MECKLENBURG COUNTY HEALTH DEPARTMENT

APPLICATION FOR PERCOLATION TEST

SUBJECT: APT #7046 (S & T Development Company)
Lot No. 11, 1301 Matthews Mill Road
Reverdy Woods Subdivision
1-7-74

SITE DISAPPROVAL REPORT
INDIVIDUAL SEPTIC TANK SYSTEM WITH SUBSURFACE, SOIL ABSORPTION, EFFLUENT DISCHARGE

DIAGRAM OF PROPERTY

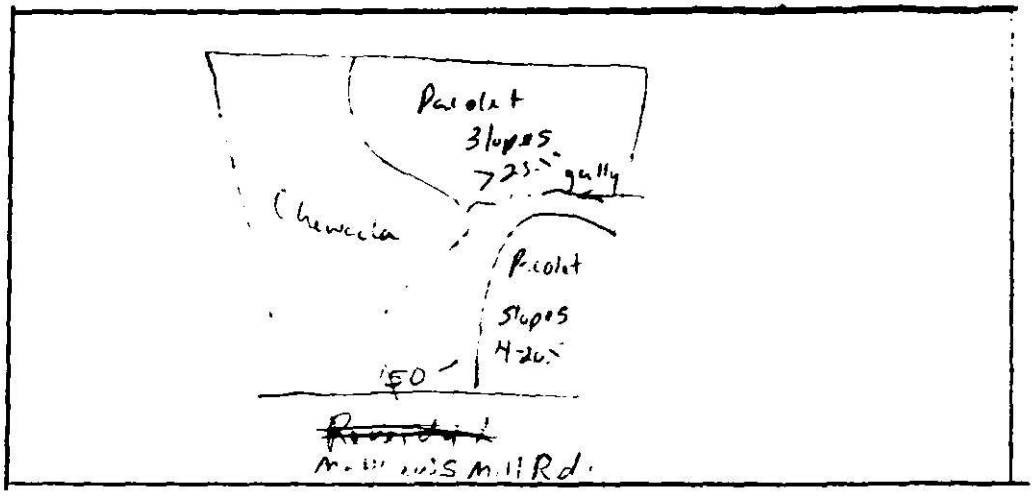
Soil Properties	Soil 1	Soil 2	Soil 3	Soil 4
1. Soil Series	Pacolet	Pacolet	Chewacla	
2. Soil Slope	acceptable 4-20%	unacceptable 25+% complex slopes	—	
3. Soil Depth	unacceptable <30"	acceptable 48"	—	
4. Soil Texture	acceptable clay	acceptable clay	—	
5. Soil Structure	unacceptable subangular blocky	acceptable subangular blocky	—	
6. Restrictive Horizons	—	—	—	
7. Soil Drainage	acceptable well drained	unacceptable lateral water movement	unacceptable seasonal high water table <18" from surface unacceptable poorly drained	
8. Soil Permeability (Percolation Rate)	acceptable >120 min/in	acceptable 60 min/in		
9. Other	—	—	unacceptable floods	
10. Overall Rating	unacceptable	unacceptable	unacceptable

Recommendations Based on this investigation the lot is not recommended for installation of a septic tank system.
